## Determination 2012/046

### Refusal to issue a code compliance certificate for an 18-year-old house at 361 Oira Road, Drury

2.5 The aluminium joinery units are set into specially cast sections of the stonework. The following Figure 1 is an interpretation of the window installation based on the expert's descriptions, photographs, and technical literature:

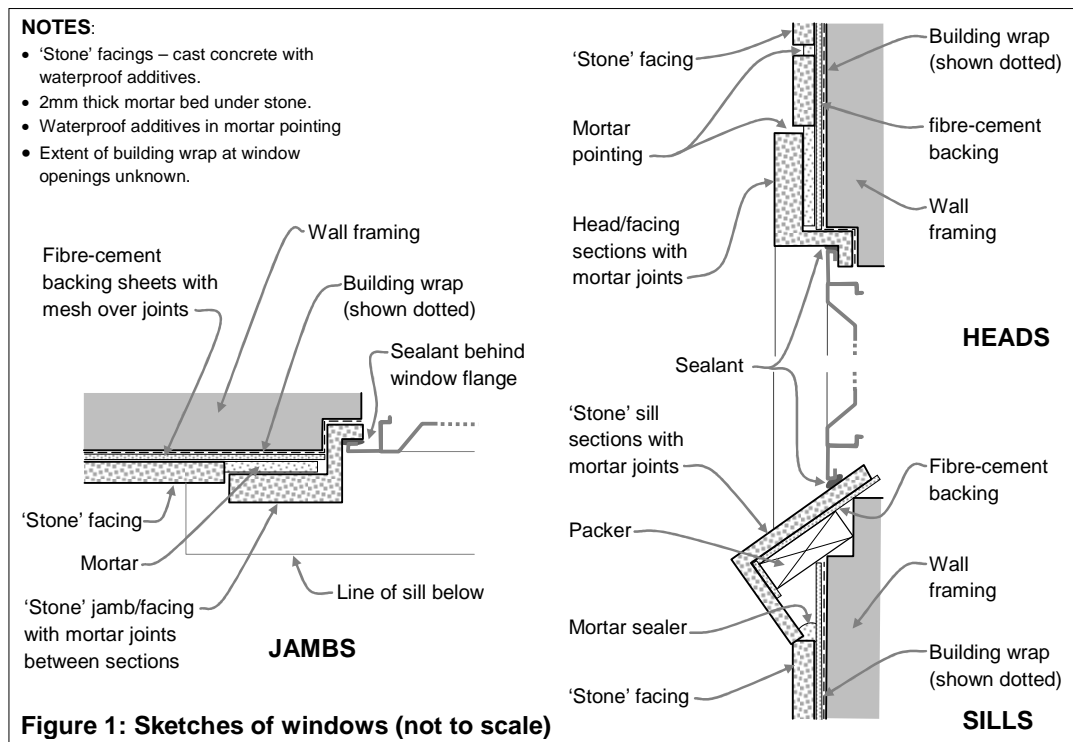
- The junction between the sill and jamb sections at the exterior joinery units provide a possible avenue for water to enter by capillary attraction should a crack open up. Also, there was no obvious “escape route” for any moisture that entered these junctions.

- The head section terminated behind the joinery units and this elevated the sealant to a “critical” status, although the depth of the head recess provided additional protection. In addition, the flat surface of the head cladding could allow water entry that did not have an easy escape route, and this was occurring in at least one location.
